COMPREHENSIVE PLANNING COMMITTEE MEETING Tuesday, June 25th, 2024, 12:00 noon AGENDA

**Re: Fountain Hill Elementary School – Land Use of Regional Significance
Fountain Hill Borough
Lehigh County**

**Re: Peregrine Tower – Land Use of Regional Significance
City of Allentown
Lehigh County**

**RE: Easton Commerce Park – Land Use of Regional Significance
Wilson Borough, City of Easton and Palmer Township
Northampton County**

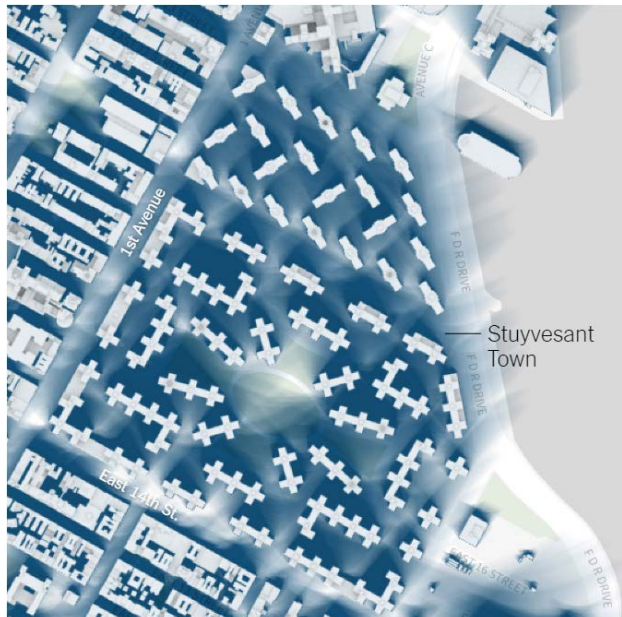
The concern that a 33 to 37-story structure would not be wholly compatible with the adjoining neighborhood remains. In particular, the proposed project is in a Traditional Neighborhood Development (TND) Overlay District which urges similar heights between new construction and the existing adjacent structures (City of Allentown Zoning Ordinance §660-51). The developer should work closely with the city planning team to better understand impacts, if not already underway. This is an excellent opportunity to organize a community and region-supportive development that minimizes or eliminates externalities. Facade design, for example, can greatly reduce the dark tunnel effect of a building this tall on the neighborhood.

The LVPC recommends the developer clarify the proposed height, in feet, of the building. Additionally, it is recommended that the developer provide shadow diagrams to determine how lights and shade impact surrounding lower-scale buildings and public spaces.
